A RESOLUTION Approving MODIFICATIONS TO THE  
STAGE 2 APPROVAL FOR THE "VILLAGES OF WINDING CREEK" R-1A  
PUD. THE REQUEST IS BY DAVID OAKES, AGENT FOR VWC HOLDINGS  
LTD.

### NOTICE OF ZONING VIOLATION

23-BZA-009 Exhibit 10B

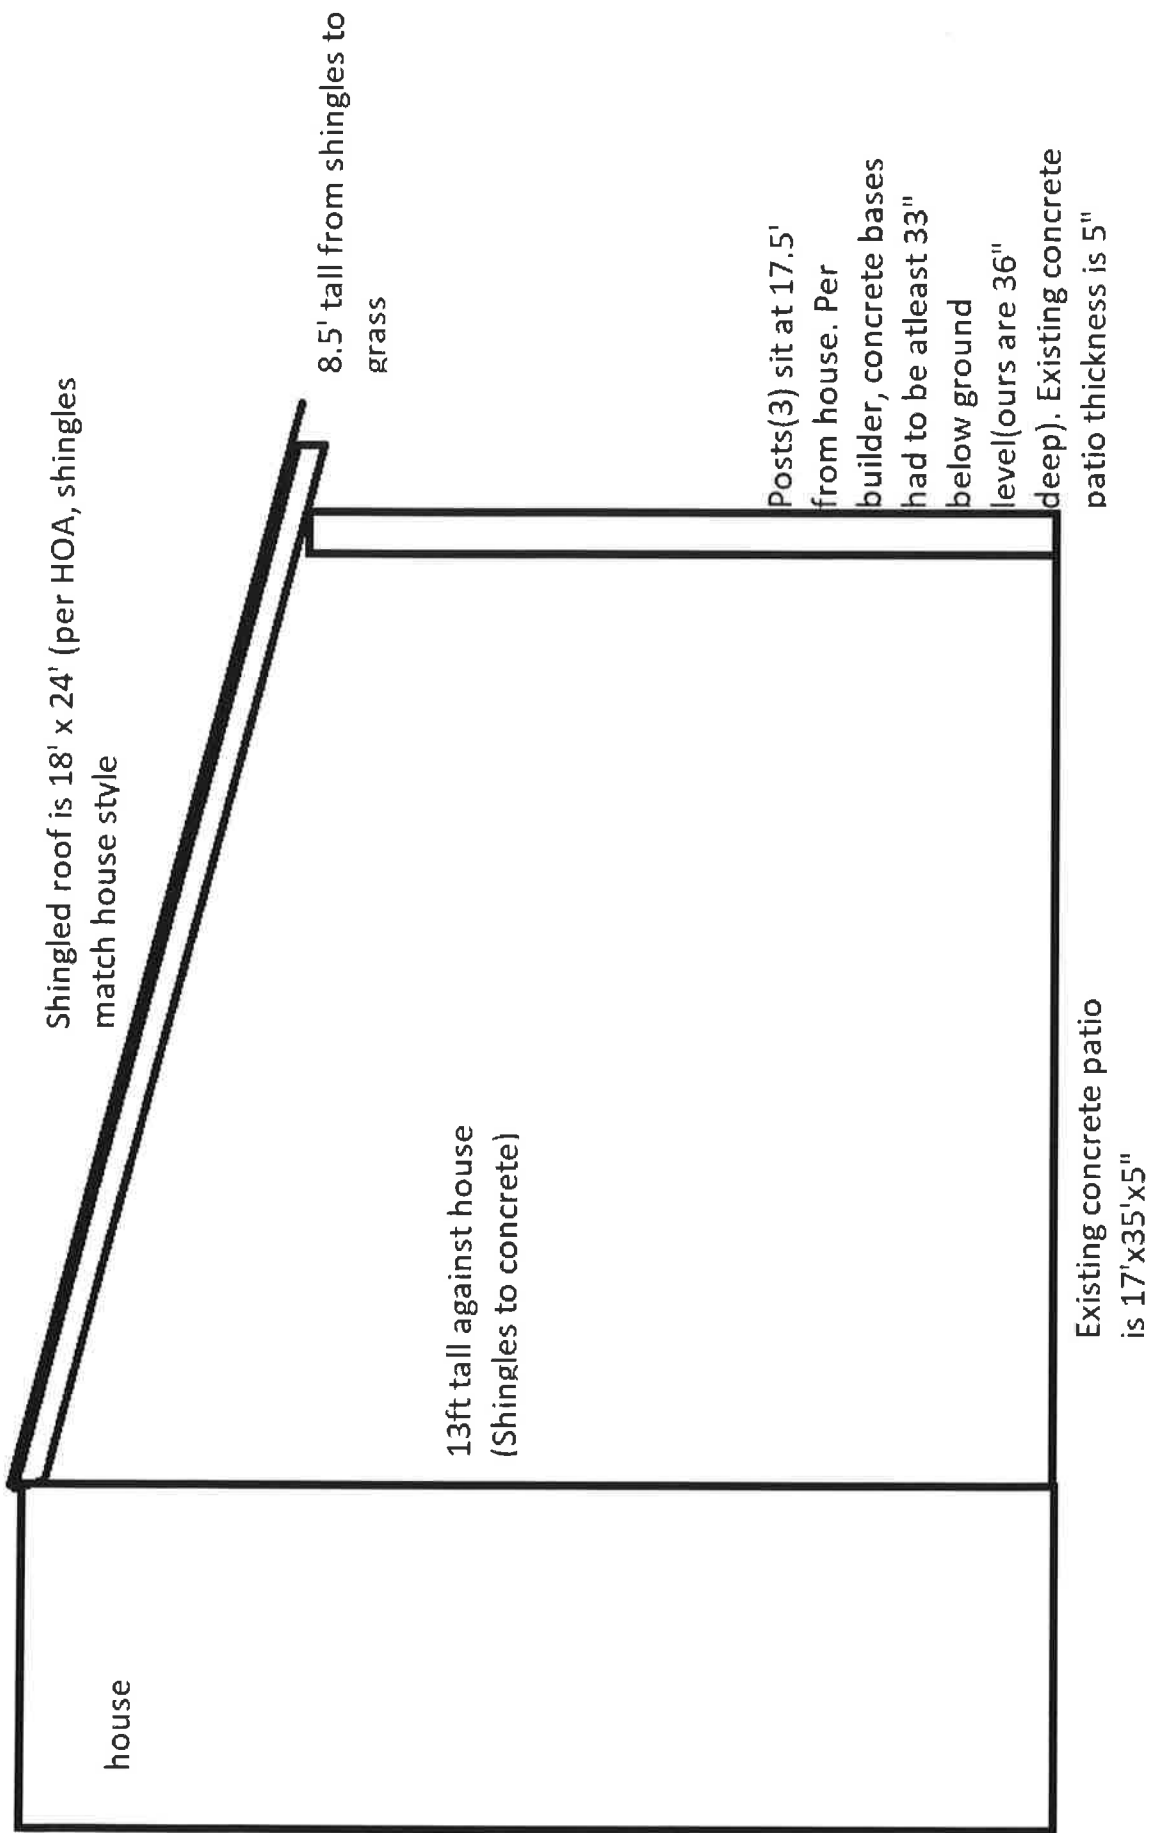
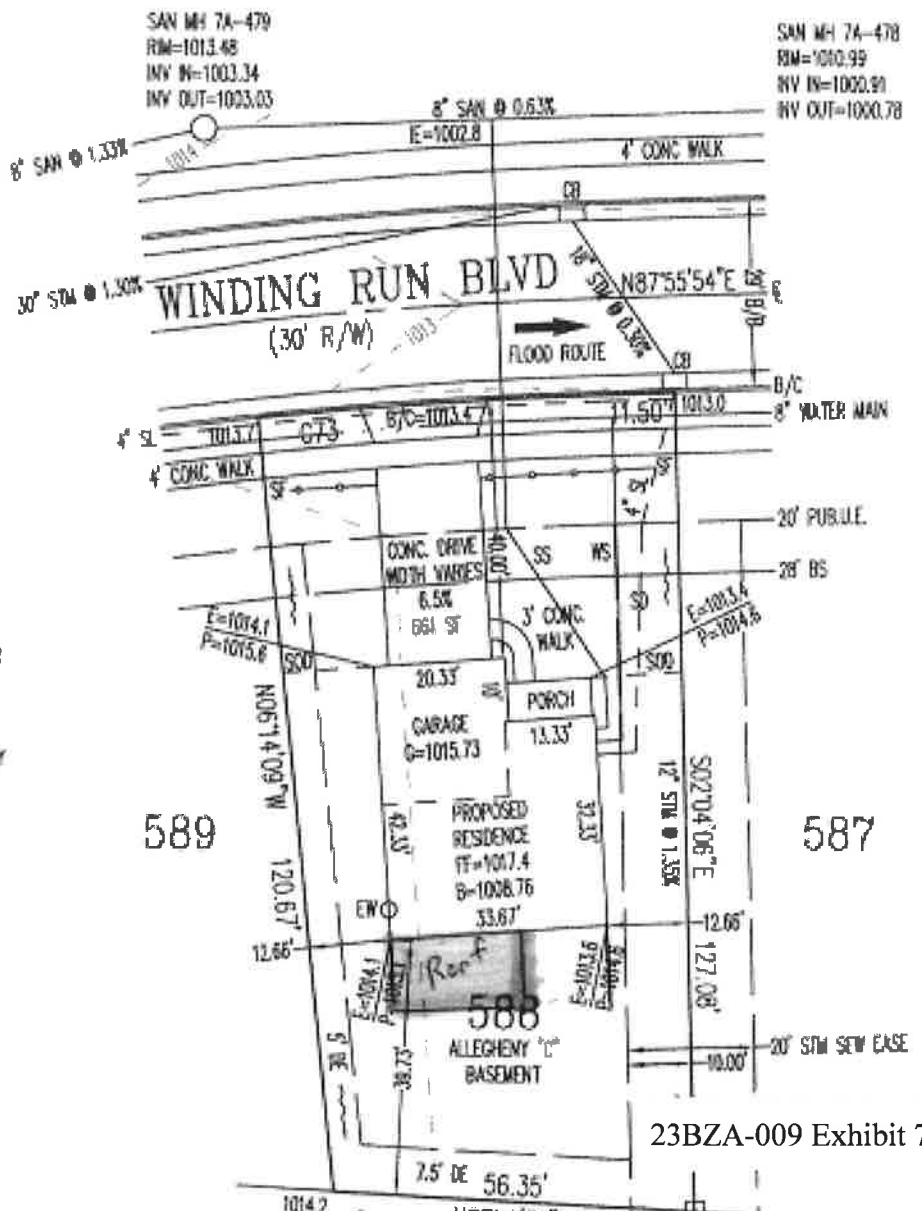
11/28/2022      Proposed roof addition encroaches into the required rear yard setback by 2.27'. Unable to issue zoning permit.

Based on the submitted plot plan and drawing you are requesting a 17'x35' roof addition for your existing patio. Since the roof is connected to the house, it is an extension of the principal structure. Your lot size in the Village of Winding Creek R-1PUD requires a minimum of a 25' rear yard setback (from property line to vertical element of the structure). The submitted plot plan identifies the rear setback for your home before the proposed roof addition to be 39.73'. The rear yard setback for the roof addition calculates to 22.73'. This roof addition encroaches into the required rear yard setback by 2.27'. I am unable to issue a zoning permit for the addition as proposed. Concrete, asphalt or paver patios are not required to meet zoning setbacks. Please contact me with questions.

- 2. Obtaining a zoning permit for the covered patio that meets Trustee Resolution 3632 Condition 23 D5. (Sec attached)**

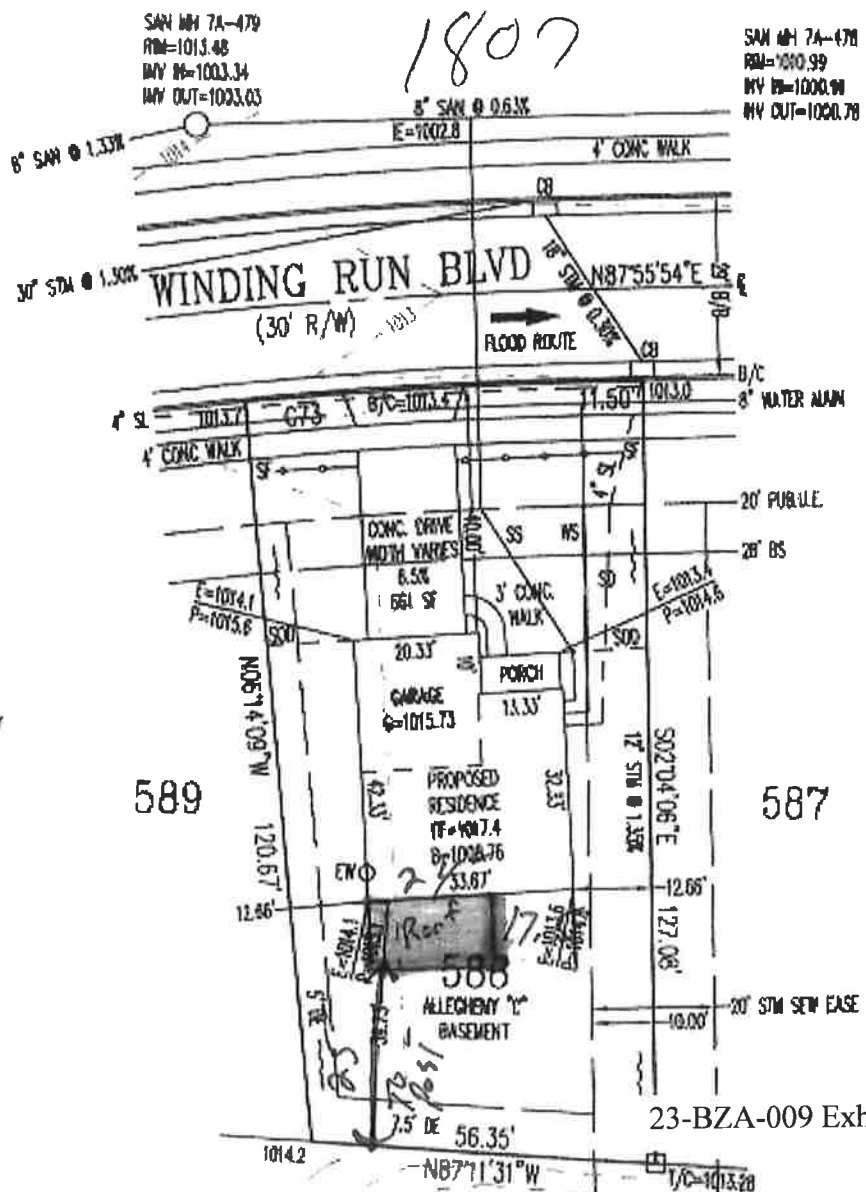
Correct sir, you stated that the vertical part of the structure was the beginning of the 25' from the back of the property.

Thank you for the updated information. I have a question regarding the placement of the posts. Does the 14.5' dimension from the house include the depth of the post?

REAR YARD=25'
